Solicitation No. 26-FM-0010

Amendment No. 3

ADDENDUM NO. 2

Project: Oklahoma Department of Transportation – Multipurpose Facility
Location: Stillwater, Oklahoma
Issued Date: 23 January 2026

1 | CW/ HW & GAS PLUMBING PLAN
1/8" = 1'-0"

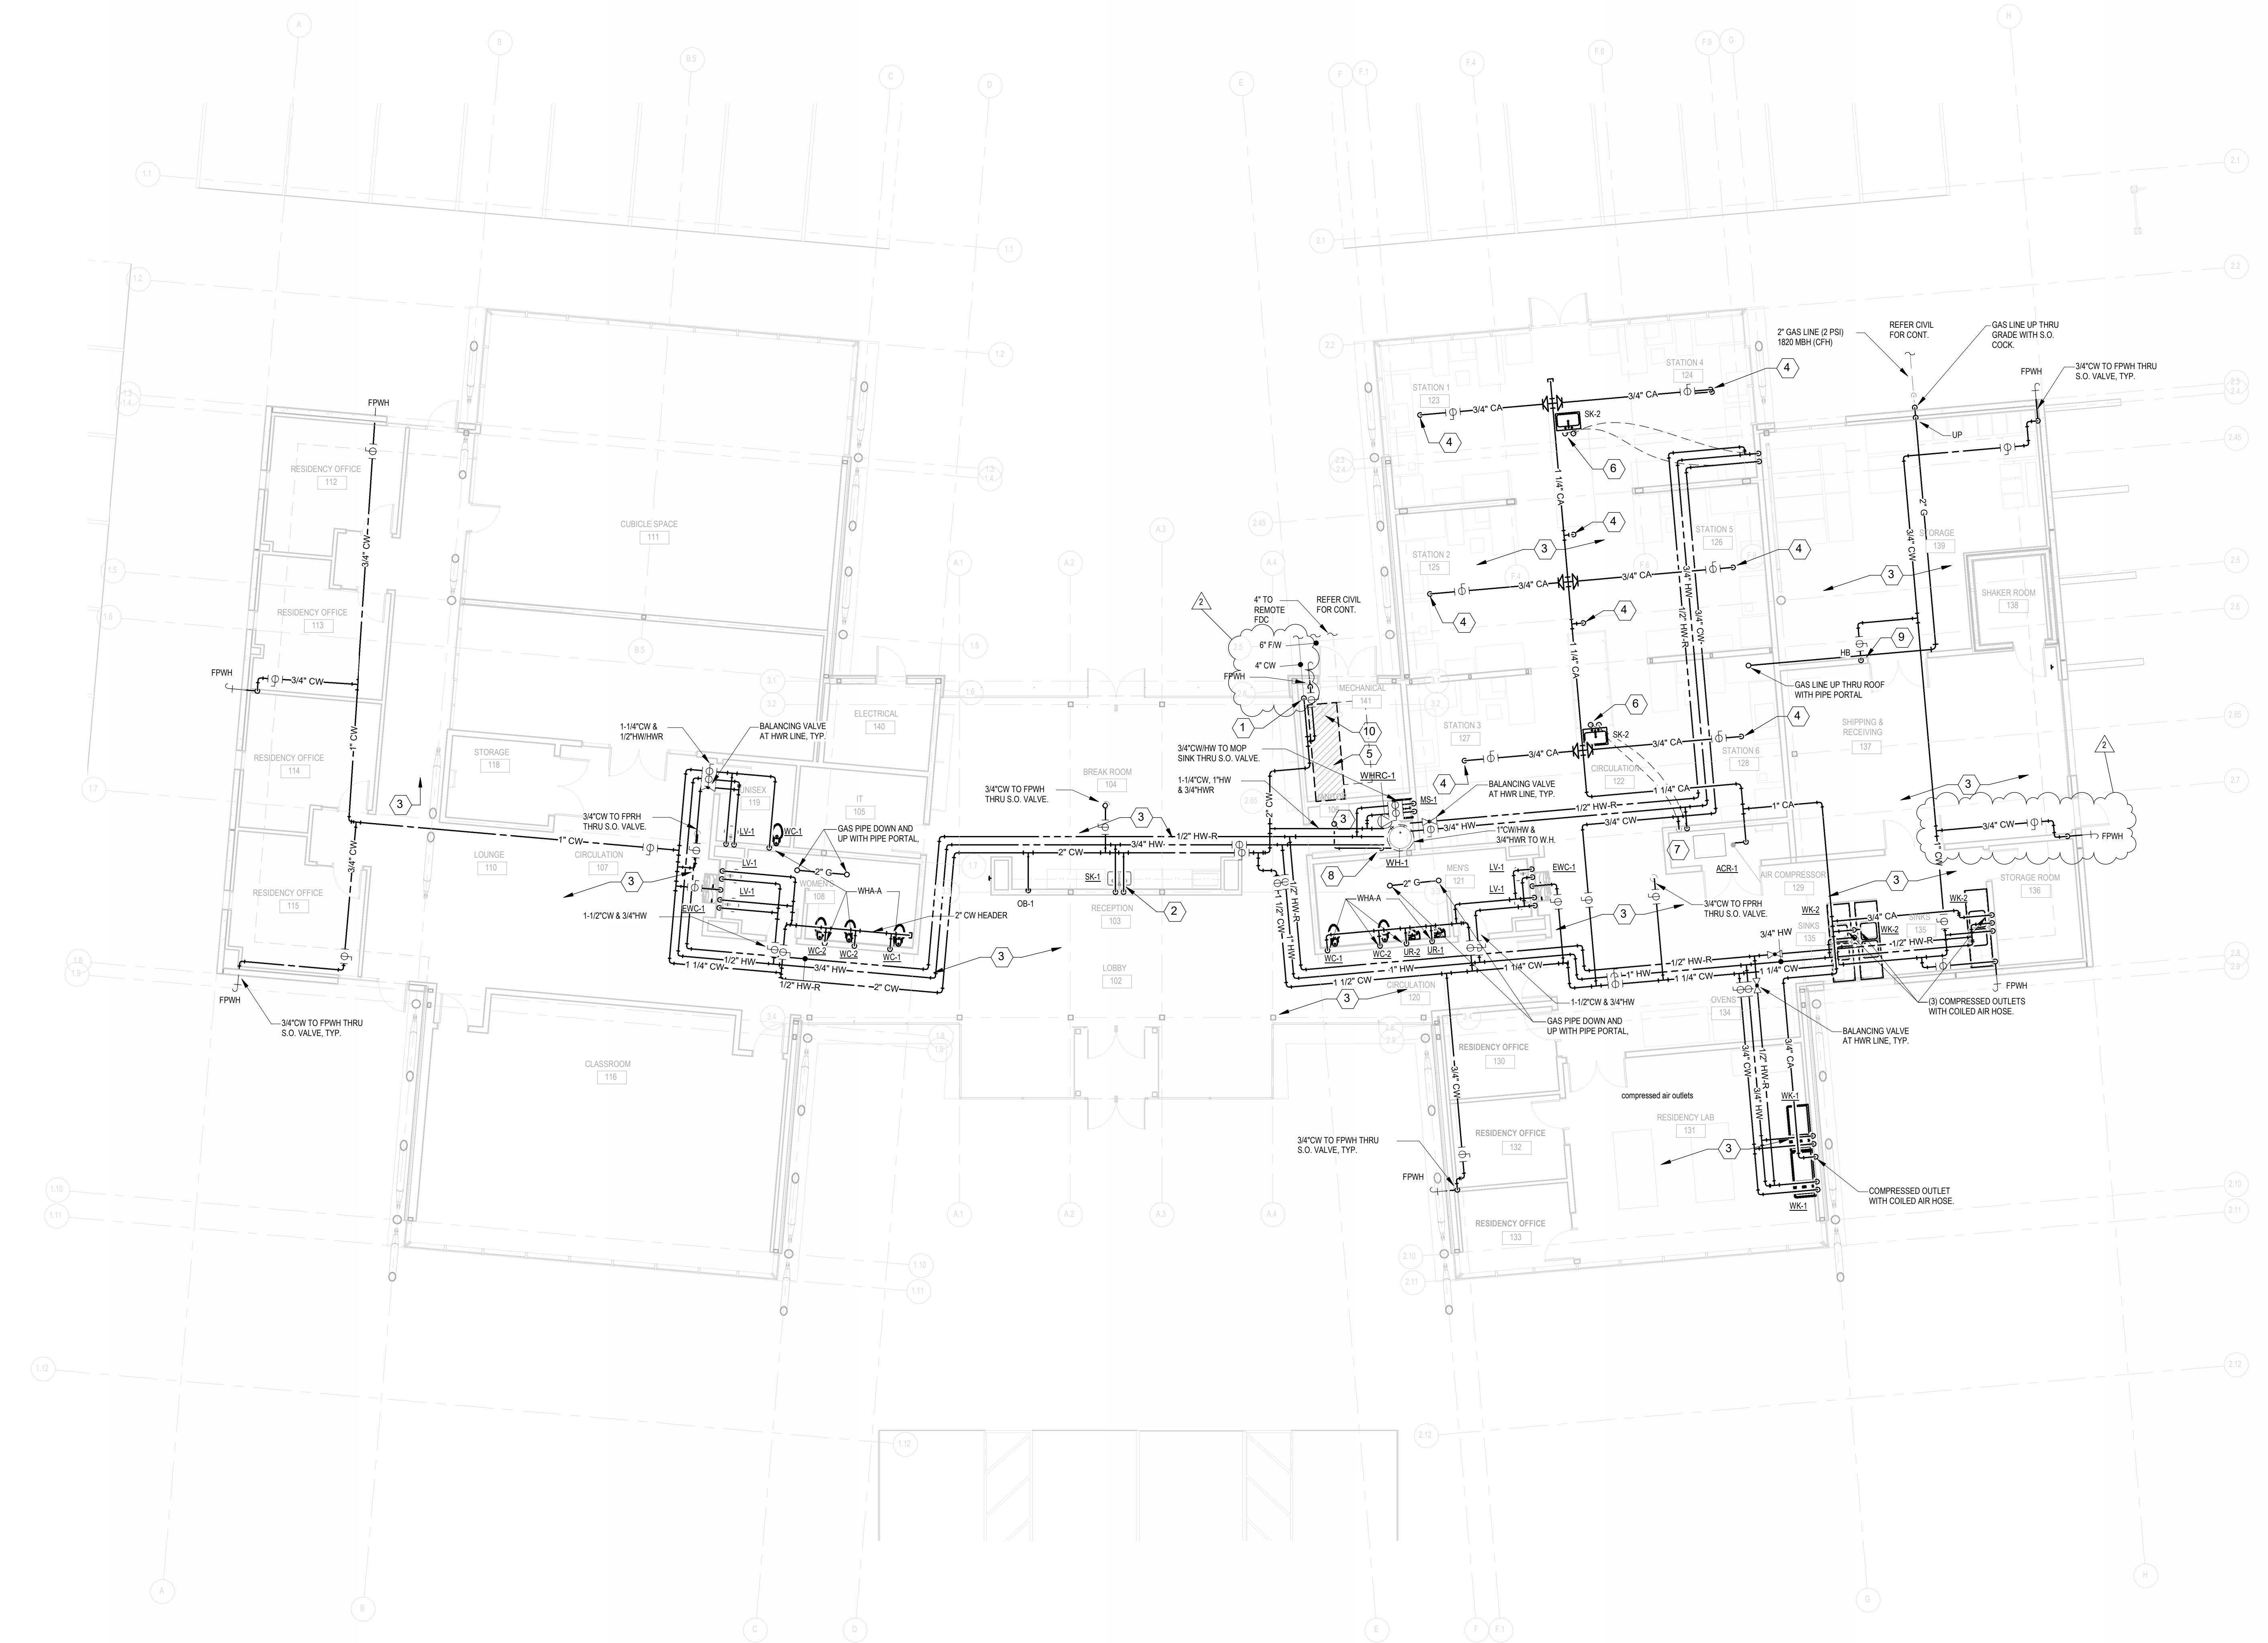
1. CW entry to building changed to 4" from 2".
2. FPWH on east side changed location.
